Office Action Summary

09/437,296

Claim 1 is rejected under 35 U.S.C. 103(a) as being unpatentable over US patent 5967489, Nakazawa et al in view of US patent 5058935, Eidsmore.

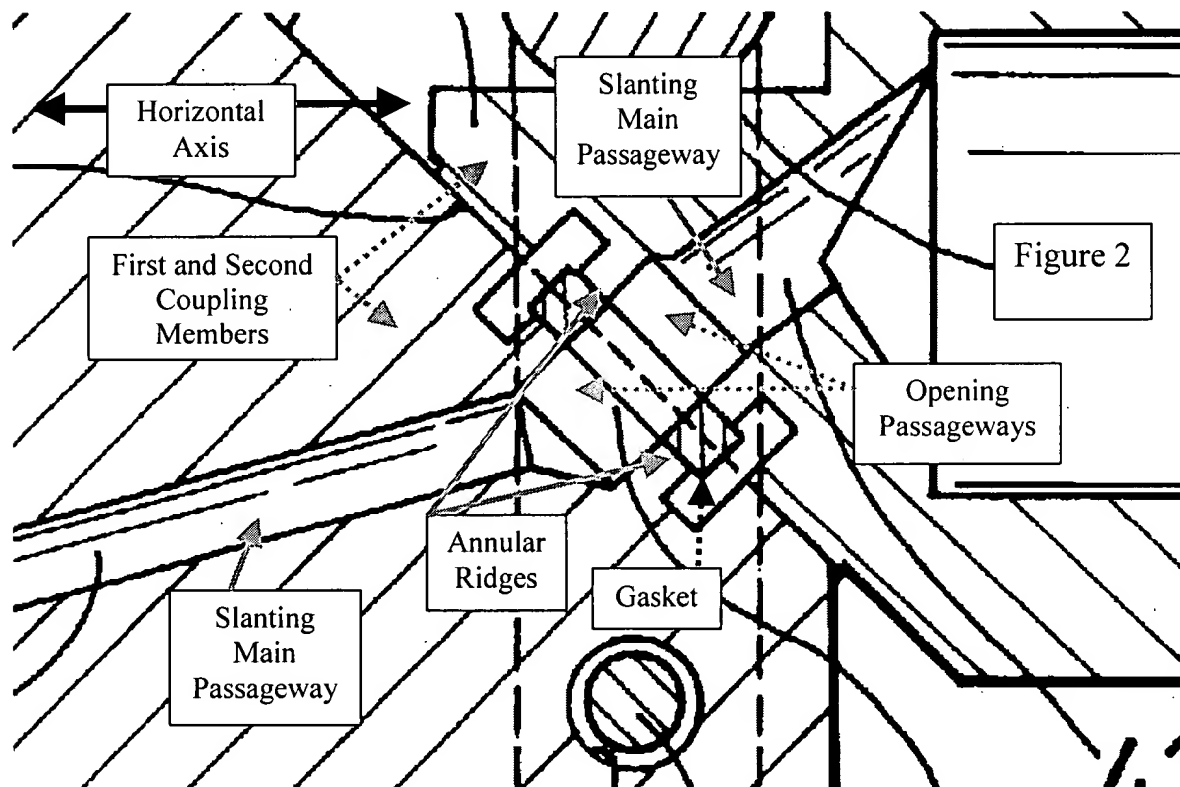
In regards to claim 1, in figure 2 below, Nakazawa et al discloses a fluid coupling comprising first and second coupling members having respective gasket holding annular ridges on butting end faces thereof; and

an annular gasket interposed between the first and second coupling members, wherein each coupling member has a fluid channel comprising an opening passageway orthogonal to the butting end face thereof, and a slanting main passageway

communicating therewith, the opening passageway having a diameter equal to the inside diameter of the gasket holding annular ridge, and

the gasket holding annular ridges are in contact with the gasket at its radial midportion so as (capable) to relieve the inner peripheral portion of the gasket from stress concentration and wrinkles.

Nakazawa et al does not disclose the gasket holding annular ridges being rounded as to be in contact with flat, non-inclined faces of the gasket only at its radial midpoint. In Figure 5, Eidsmore teaches a gasket holding annular ridges (40) being rounded as to be in contact with flat, non-inclined faces of the gasket (42) only at its radial midpoint because this a relatively conventional arrangement well known in the art (col. 4, lines 24-26). As Eidsmore relates to pipe joints employing a metal gasket, it would have been

obvious to one having ordinary skill in the art the time the invention was made to fabricate rounded gasket holding annular ridges as to be in contact with flat, non-inclined faces of the gasket only at its radial midpoint because this a relatively conventional arrangement well known in the art, as taught by Eidsmore.
